HISTORIC AND DESIGN REVIEW COMMISSION

April 19, 2023

HDRC CASE NO: 2023-099
ADDRESS: 327 E KINGS HWY
LEGAL DESCRIPTION: NCB 6327 BLK 2 LOT 50
ZONING: R-5, H
CITY COUNCIL DIST.: 1
DISTRICT: Monte Vista Historic District
APPLICANT: Oscar Flores/Oscar Flores Design Studio
OWNER: JOHN MALONEY/MALONEY JOHN PATRICK JR
TYPE OF WORK: New construction of a 2-story, single-family structure and a 1-story detached garage
APPLICATION RECEIVED: March 10, 2023
60-DAY REVIEW: Not applicable due to City Council Emergency Orders
CASE MANAGER: Rachel Rettaliata

The applicant is requesting conceptual approval to construct one 2-story, single-family structure and one 1-story detached garage at 327 E Kings Hwy.

SHEET TITLE
RIGHT & LEFT SIDE
ELEVATIONS

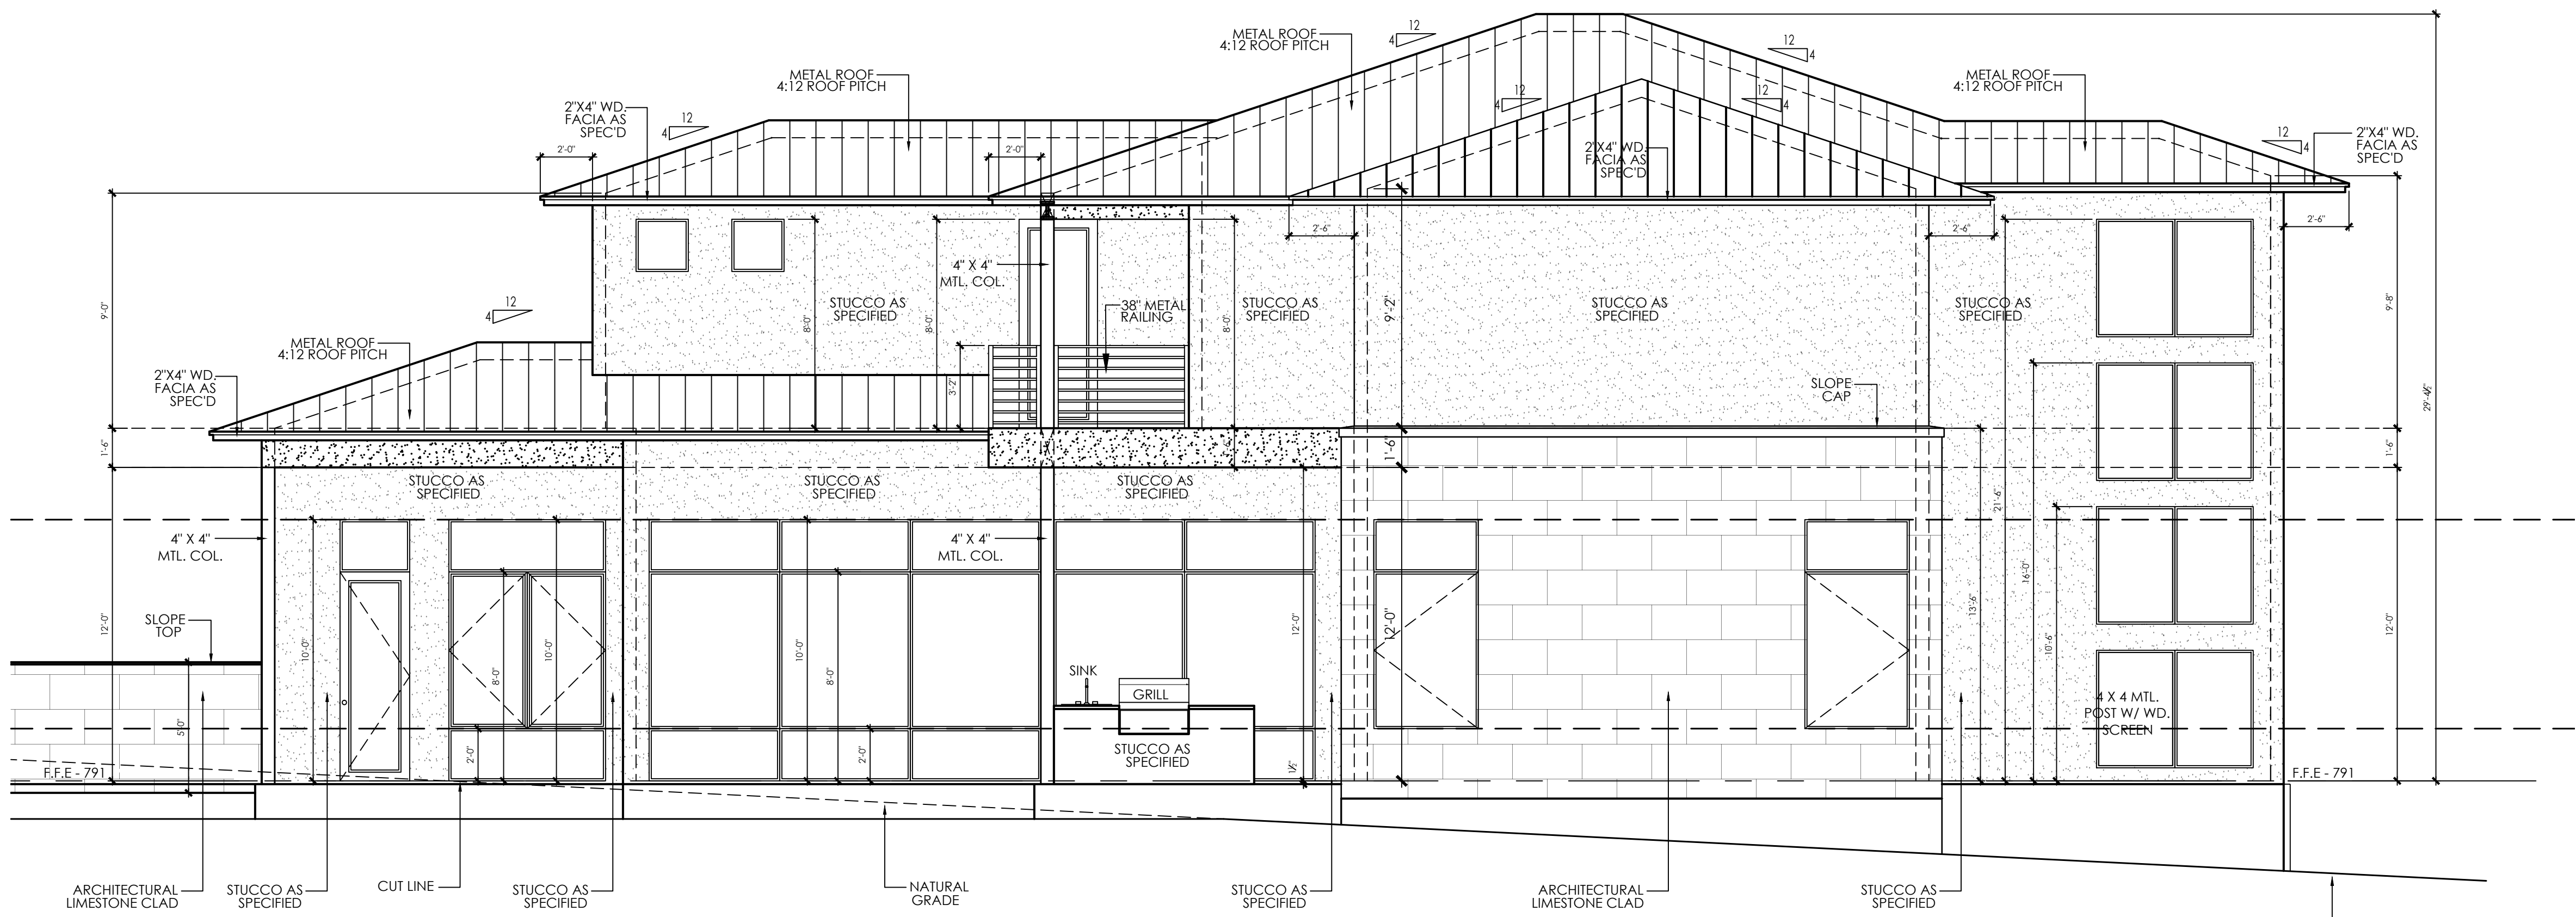
JF: In terms of fenestration, there is a large 2-story volume without fenestration on the left side elevation and from your floor plan it looks like you can incorporate some windows there. The smaller scale windows on the right side elevations, the square ones up high, are more appropriate than the long horizontal windows. I would recommend incorporating the smaller square windows.
